# GLENORCHY PLANNING AUTHORITY ATTACHMENTS MONDAY, 14 JULY 2025

5.	PROPOSED USE AND DEVELOPMENT – NEW BUILDING FOR SPORT AND RECREATION
	– 61 CLAREMONT LINK ROAD, CLAREMONT

## GPA – Attachment 1 Site Plan, advertised plans, and TasWater Referral

Figure 2 Pre-development Flood Hazard Extents

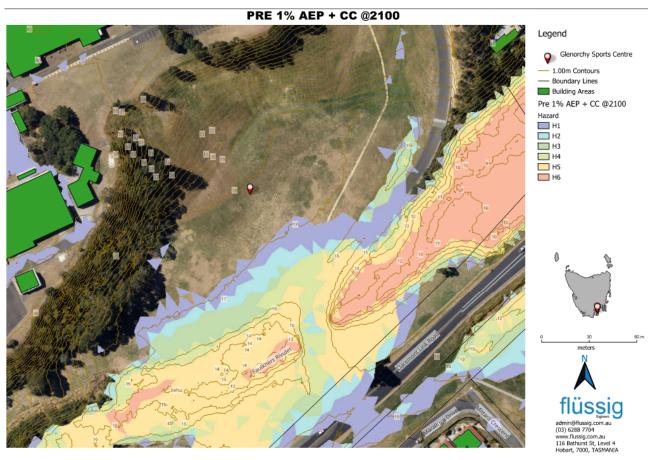
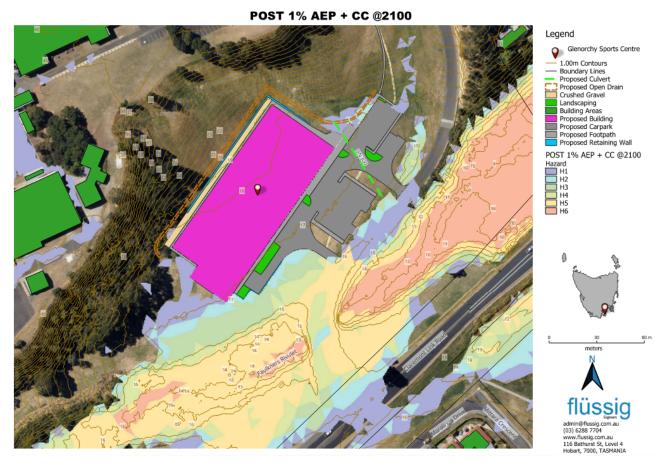
Flussig report has identified that the proposed developed of the multi-sport centre at 61 Claremont Link Road is susceptible to a fast moving and deep flood flow, with the surrounding region classified in the range H1-H6 hazard rating in the 1 % AEP + climate change event. This means some areas of the site are considered generally unsafe for people and vehicles.

Therefore, Flussig report has provided a range of recommendations including:

- Raising the finished floor levels higher than the 1% AEP flood in accordance with Building regulations;
- Adoption and maintenance of flood management plans to all on-site facility users;
- No additional solid structures be constructed around the property without further flood assessment;
- Construct a new cutoff drain along the western side of the proposed facility, positioned at the top of the proposed retaining wall;
- Install a new DN300 pipe and associated pits to facilitate dewatering of the northern corner of the facility area, or implement any other structures that can achieve similar results; and
- Landscaping around the driveways and carpark areas should consist of stabilised, non-erosive materials.
